Agenda Page 1
Attachment 1 - PLN18/0902 - 48 - 50 Gipps Street Collingwood - Advertised S52 - Plans Part 1

MEMO

Subject: Application No: PLN18/0902

Site Address: 48-50 Gipps Street, Collingwood

LOCALITY PLAN

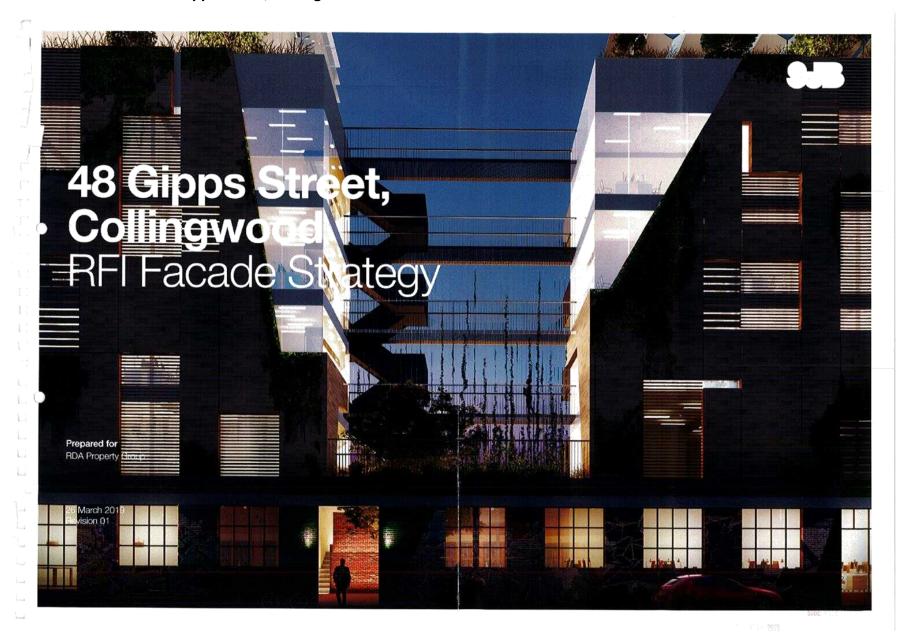
Item	Details				
'Shared Zone' Type Treatment – Ro	okeby Street				
Proposal	As part of the proposed development, the applicant wishes to introduce a painted treatment on Rokeby Street to activate their building. The painted treatment would effectively privatise this section of Rokeby Street (a Public Highway).				
	The painted road pavement treatment would create a less hostile				
	environment for pedestrian and cyclists using this section of Rokeby Street.				
Shared Zones	Shared Zones are speed limited areas under the provisions of the <i>Road Safety Road Rules</i> 2017 and are classified as Major Traffic Control Devices, which must have VicRoads authorisation. Being speed limit signs, Shared Zones have statutory significance under the <i>Road Safety Road Rules</i> , and motorists are obliged to give way to pedestrians. Shared Zones are defined by area signs (at entry) and end area signs

Normally where roadways encourage active pedestrian usage, Shared Zones would be considered. Shared Zones are ideal where the road space contains traffic treatments, seating, plantings in the road space.				
	In this instance, Council will not be pursuing the introduction of Shared signs for Rokeby Street.				
Additional Engineering Requirements					
Reconstruction of Rokeby Street	The Rokeby Street road frontage of the site will provide primary pedestrian and bicycle access to the offices above the ground floor of the site. Currently, the existing asphalt pavement and bluestone central spoon drain contains a number of depressions that retain water after a storm event and has an uneven surface that is not suitable for pedestrians.				
	It is recommended that the full-width of Rokeby Street between Gipps Street and Singleton Street be reconstructed – see Locality Plan.				
	During building works at the site, Rokeby Street will sustain damage caused by the passage of construction vehicles, plant and other equipment which would necessitate reconstruction of Rokeby Street.

Item	Details				
Additional Engineering Requirements					
Preparation of Detailed Road Infrastructure Design Drawings	The developer is to engage a qualified civil engineering consultant to prepare a reconstruction design for all road and drainage infrastructure works associated with this development for assessment and approval.				
	Essentially the works would include excavating the bluestone and asphalt overlay.				
	The sub-base would need to be prepared and a new pavement constructed. The new pavement would comprise of an asphalt with a bluestone central invert.				
	These works must be undertaken to Council satisfaction and Engineering specification.				
	A longitudinal section plan of Rokeby Street at 5.0 metre intervals should be provided to ensure that access to exiting doorways abutting Rokeby Street is maintained.				
Painted Road Pavement Treatment	As part of the reconstruction of Rokeby Street, Council's Civil Engineering Unit and Traffic Engineering Unit recommend the installation of a painted road pavement treatment to encourage a pedestrian-friendly road environment. The design of the proposed pavement treatment is to be independent of any artwork proposed for the façade of the building. The developer is to engage their own design consultant to prepare a pavement treatment and design for this section of Rokeby Street for Council's consideration and approval.
